**Planning Board Meeting Agenda
Brunswick Town Hall
85 Union Street – Council Chambers
Tuesday, February 10, 2026 @ 6:00 PM**

4. **Case No. 25-059 – MaineHealth Mid Coast Cancer Center Renovation:** The Planning Board will review and act upon a **Site Plan Amendment** application submitted by Pine Tree Engineering on behalf of the property owner, Mid

DRAFT FINDINGS OF FACT SKETCH PLAN MAJOR DEVELOPMENT REVIEW PLANNING BOARD

DATE: 10.28.2025
SHEET TITLE AND NUMBER:
AS3.00
CIVIL DETAILS

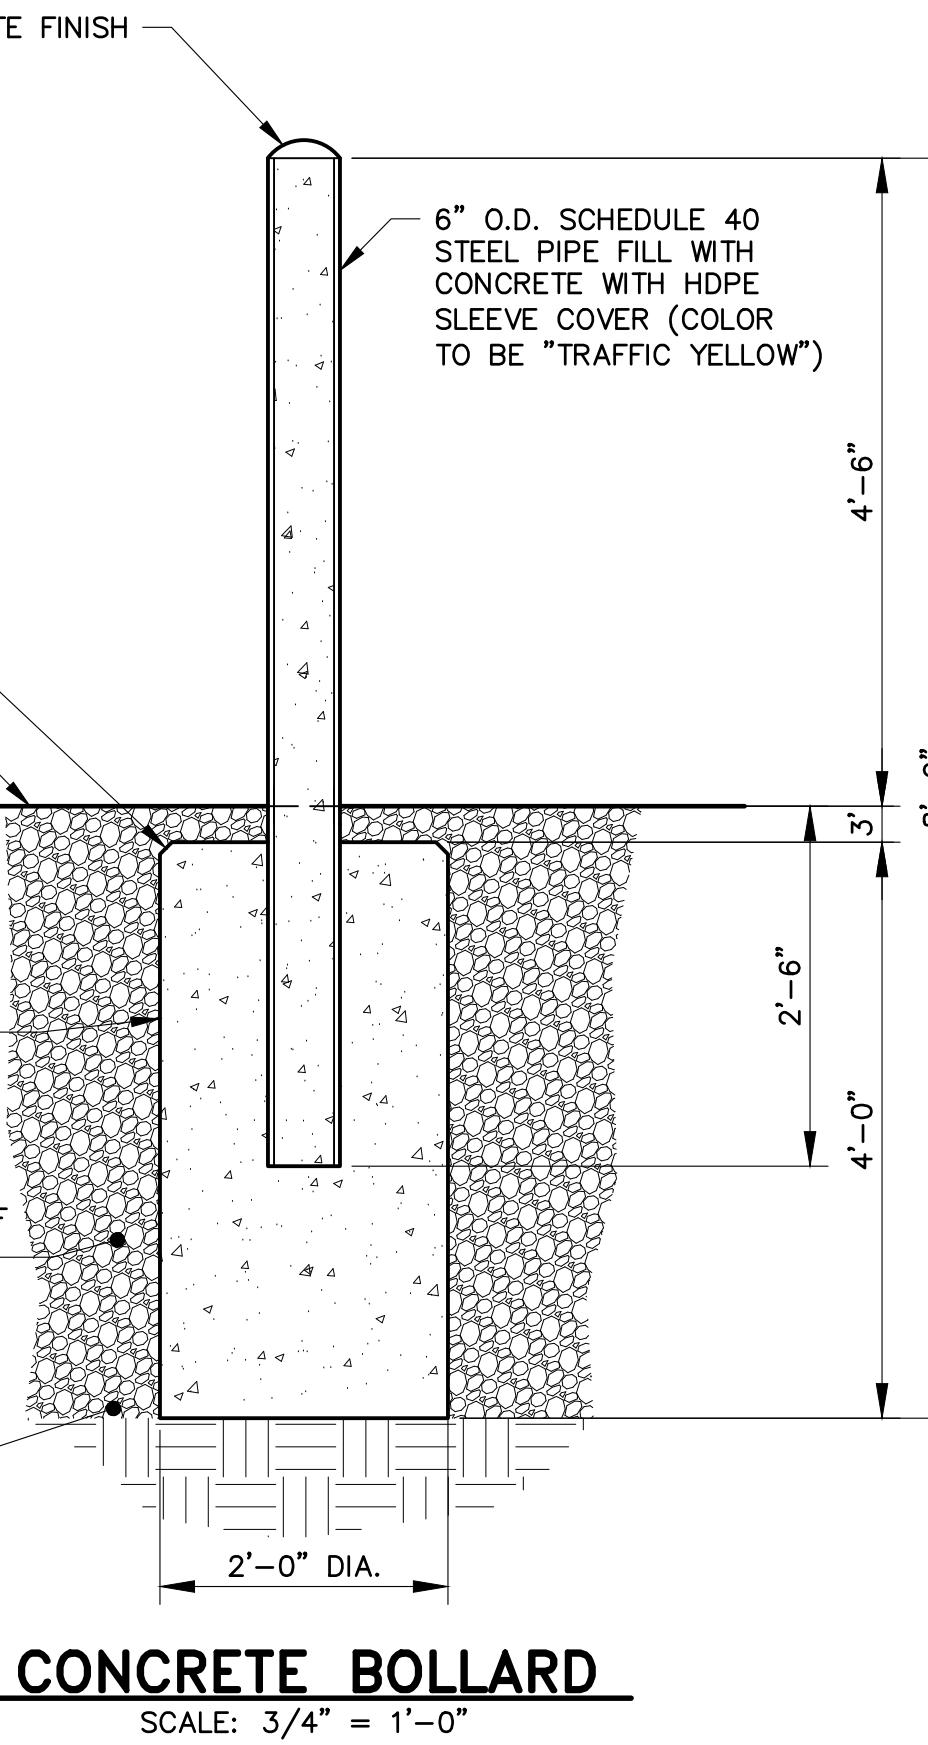
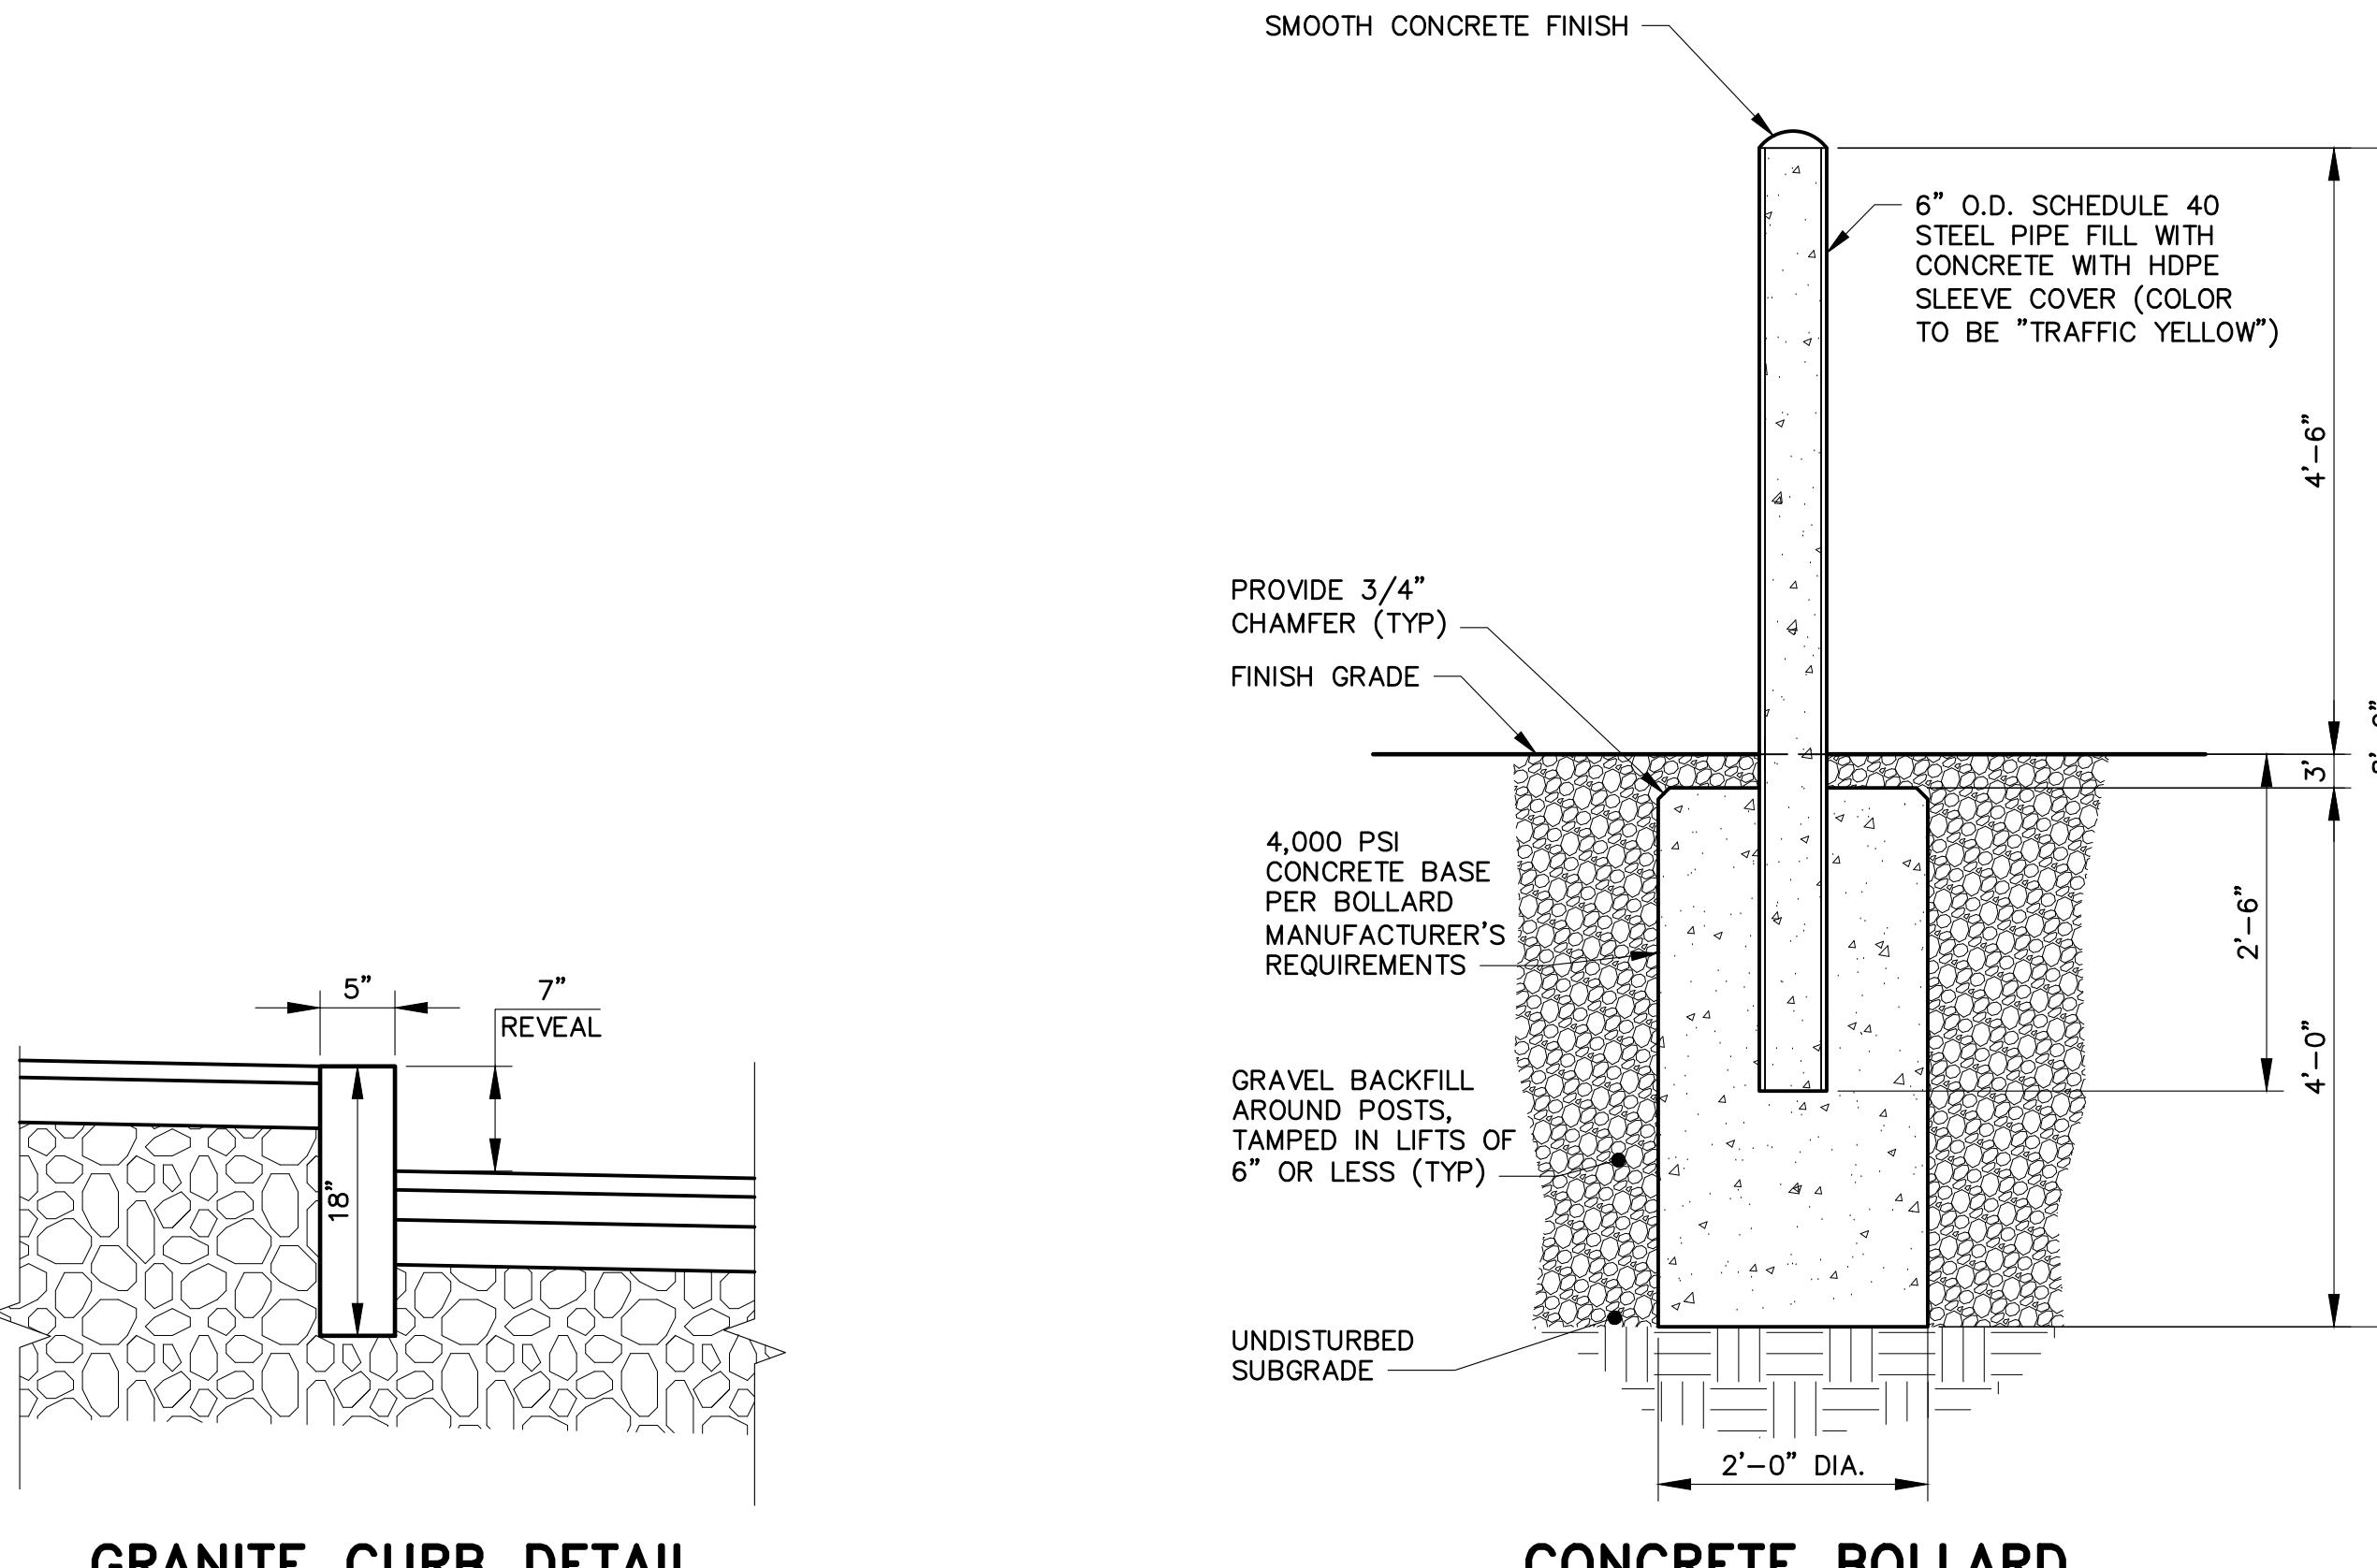
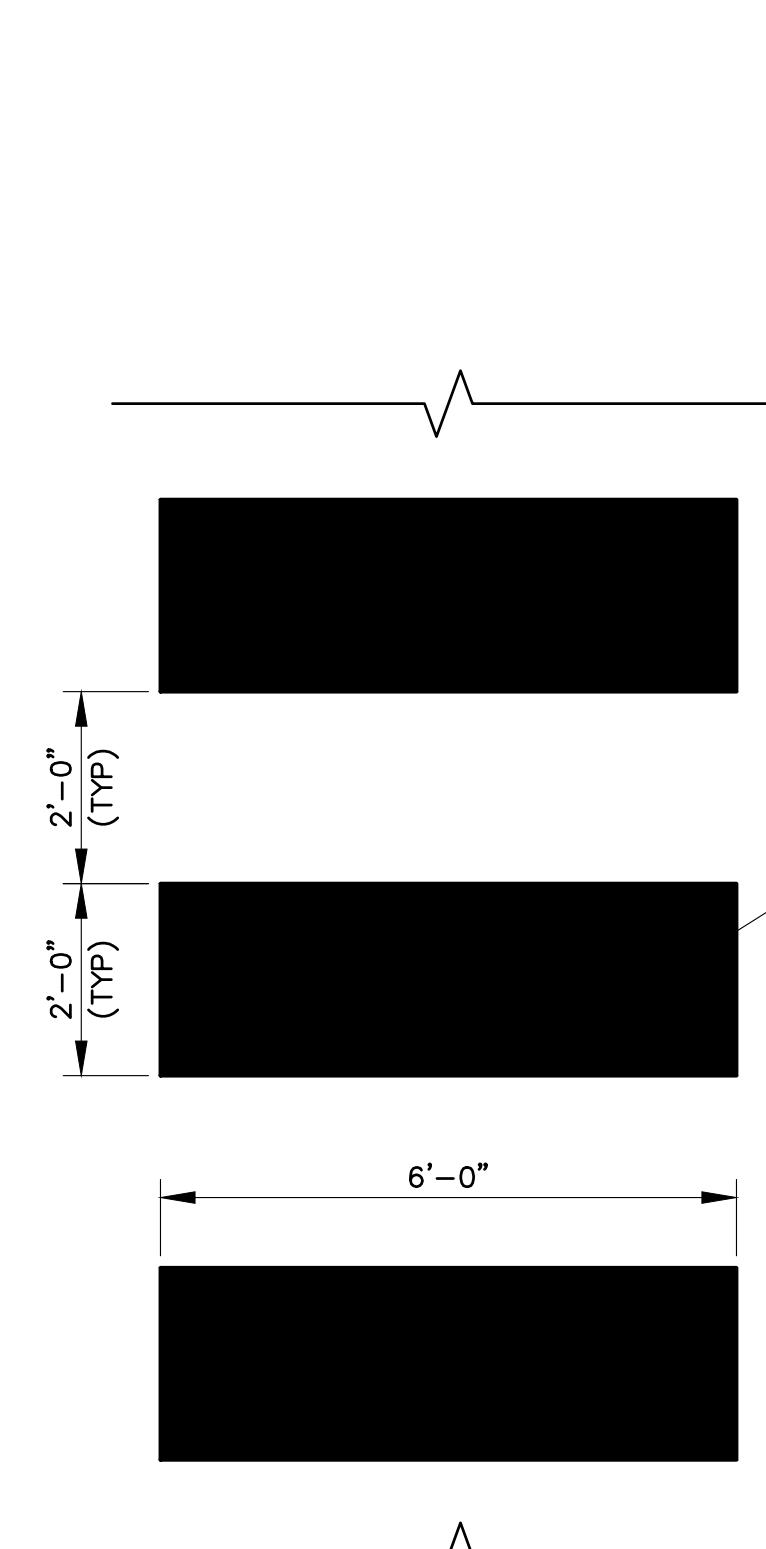
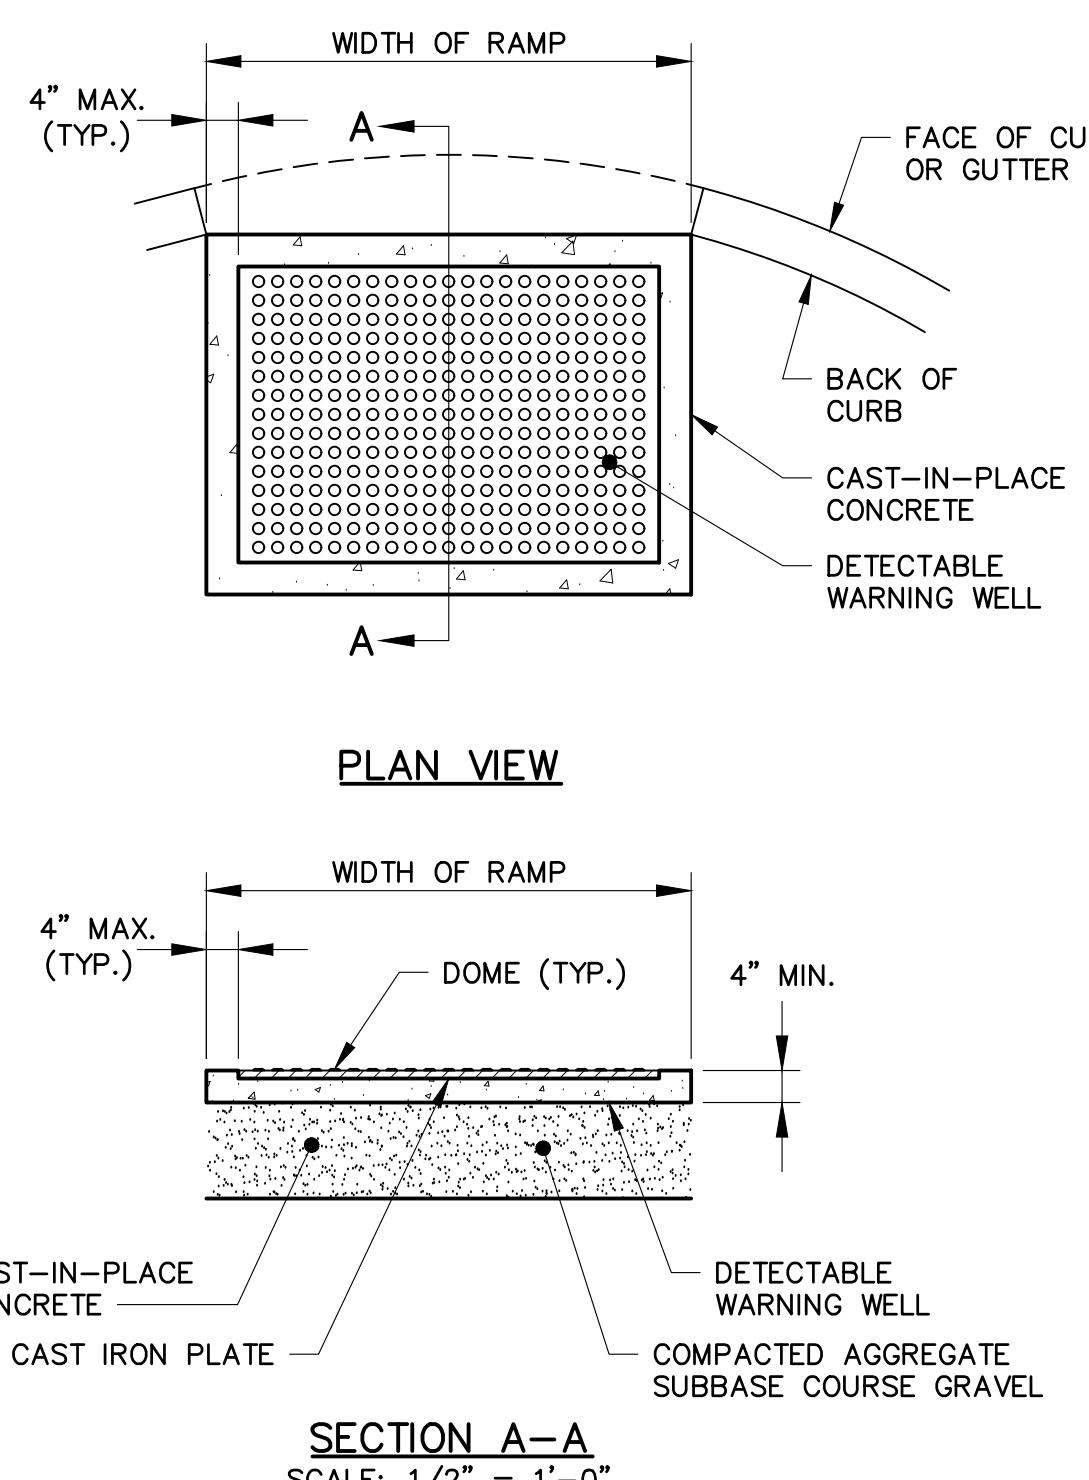
3. Add ornamental grass along parking lot side of pharmacy, near bollards	See Section B-B on AS3.00 Civil Details
Architecture Comments	
4. Review Cooks Corner Design Standards, specifically Section 3.4 Fa?ade Requirements, and within 3.4.j.	See Exhibit 8: Cook's Corner Design Standards Narrative.
Engineering Comments
